Illinois Tollway Base Sheet Revisions

Section M	Base Sheet Drawings		
	Drawing	Modification Summary	Effective: 03-31-2016
	All	The electronic (pdf) version of the Standard Drawing are now made searchable (text).	
Erosion Sediment Control (ESC)-Series 200			
M-ESC-205	Sediment Basin Dewatering Device		
	Revised Note 7, removed proprietary name from skimmer device.		
Roadway (RDY)-Series 400			
M-RDY-408	Approach Slab, Mainline		
All	Changed Transverse Reinforcement size and spacing in the bottom mat of the bridge approach slab and transition approach shoulder slabs from #6@9" to #8@4" to be in conformance with IDOT ABD Memo 15.8.		
All	Changed Transverse Reinforcement size and spacing in the top mat of the bridge approach slab and transition approach shoulder slabs from #5@12" to #5@6" to be in conformance with IDOT ABD Memo 15.8.		
All	Changed Longitudinal Reinforcement size and spacing in the top mat of the bridge approach slab and transition approach shoulder slabs from #4@15" to #5@6" to be in conformance with IDOT ABD Memo 15.8.

M-ITS-1500

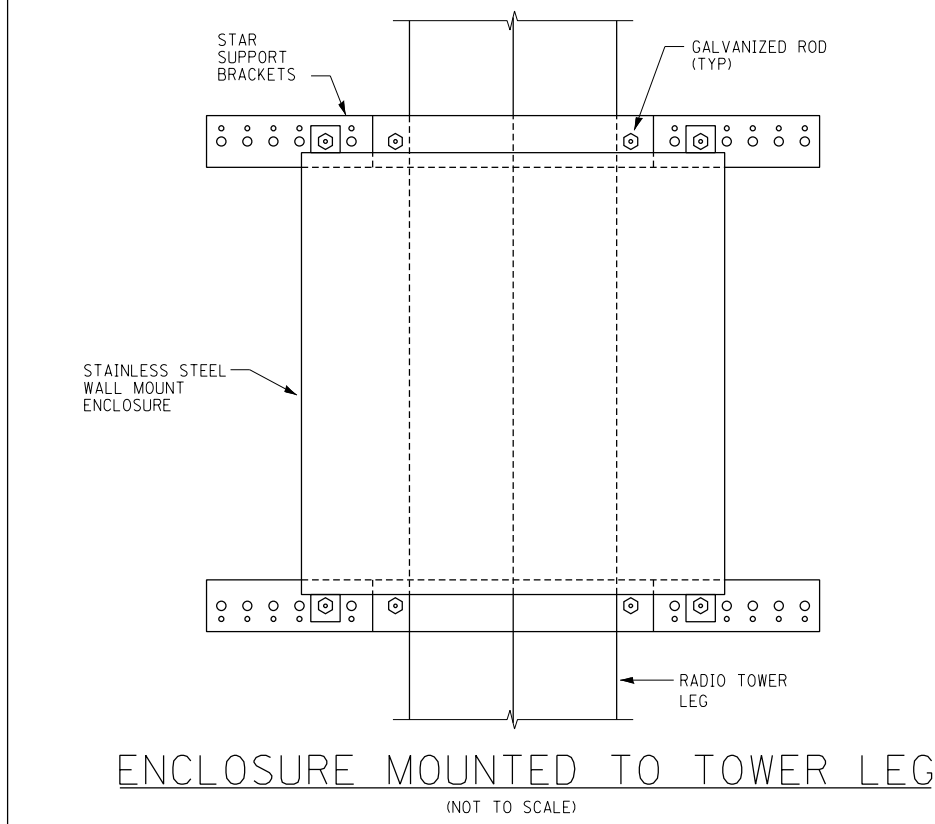
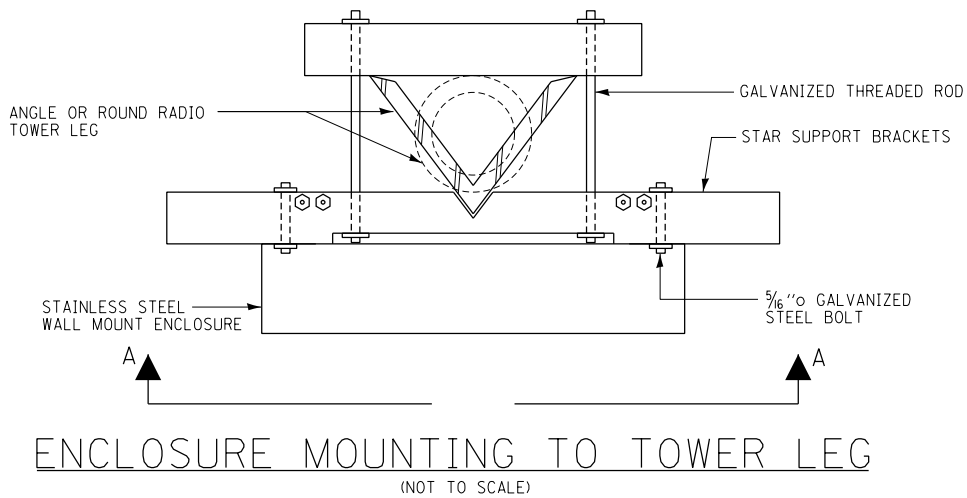
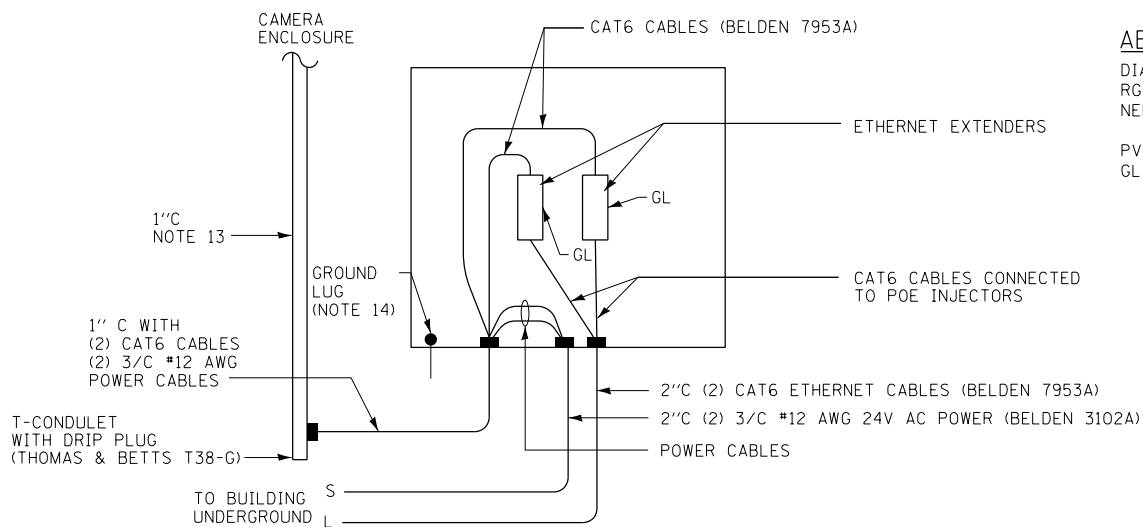
New Sheet
